Name Of Dam: MOORE

PHASE I INSPECTION REPORT NATIONAL DAM SAFETY PROGRAM

FEBRUARY 1981

NAME OF DAM: MOORE DAM
LOCATION: PITTSYLVANIA COUNTY, VIRGINIA
INVENTORY NUMBER: VA 14323

TYPICAL CROSS SECTION

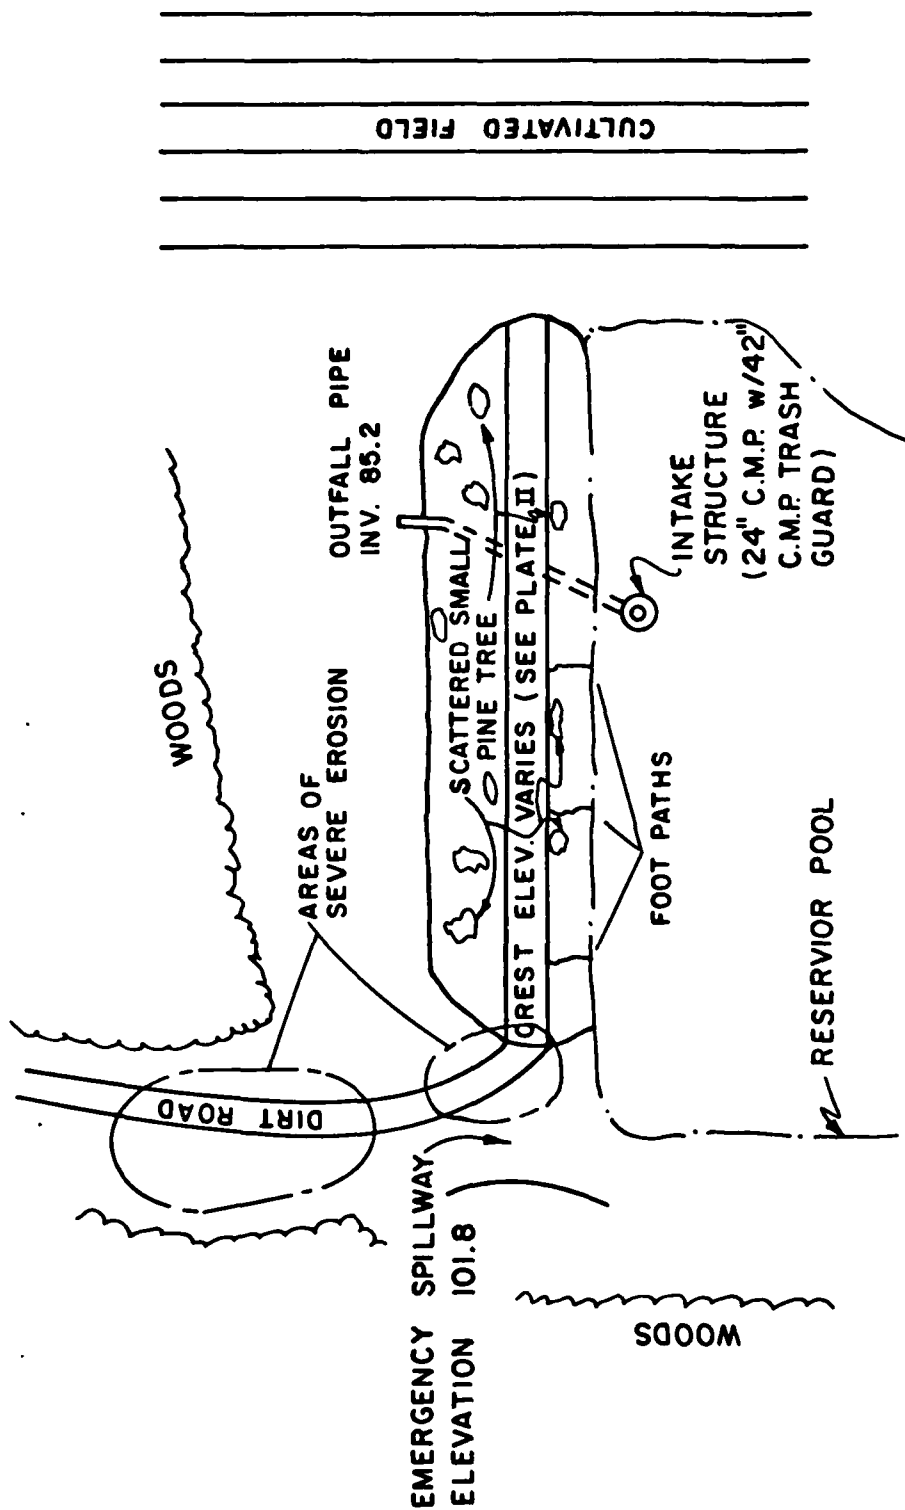
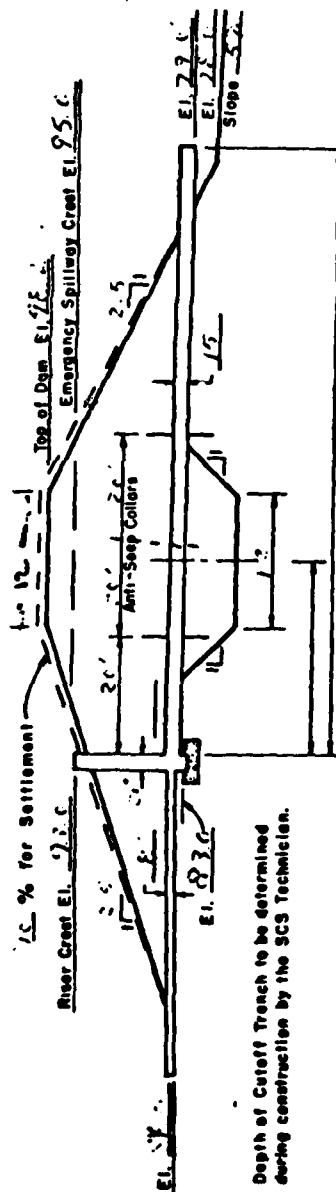
3.1.2 Embankment: A sketch of the embankment showing a cross section and crest profile is provided on Plate II, Appendix I. A plan view is given on Plate III, Appendix I.

6.2.2 Stability: There were no stability calculations available. The dam is 22.8 feet high with a crest width of 12 feet. The upstream slope is 2.5H:1V and the downstream 2.5H:1V. The dam was designed for a normal pool elevation of 100.0 TBM. The maximum storage pool is 101.9, the elevation of the emergency spillway. The upstream slope has never experienced a rapid drawdown, although it would be subject to one if the eight-inch shear gate outlet were opened, as the rate of drawdown would be 0.91 feet per day, somewhat greater than the 0.6 feet per day recommended as the maximum rate of drawdown. The dam has been subjected to the maximum control storage pool (water at the crest of or flowing through the emergency spillway) on several occasions, with no ill effects other than possible erosion to the emergency spillway channel. Actually erosion damage in the emergency spillway area is probably largely the result of surface runoff and vehicle traffic, in view of the infrequency of spillway flows.

According to the guidelines presented in Design of Small Dams, U. S. Department of the Interior, Bureau of Reclamation, the slopes recommended for a homogeneous small dam of similar material subjected to a rapid drawdown are 3.5H:1V upstream and 2.5H:1V downstream. The recommended crest width for this height is 14.5 feet. Based on these guidelines, the Moore Dam has an adequate downstream slope, and inadequate upstream slope, and a crest width a few feet less than desirable.
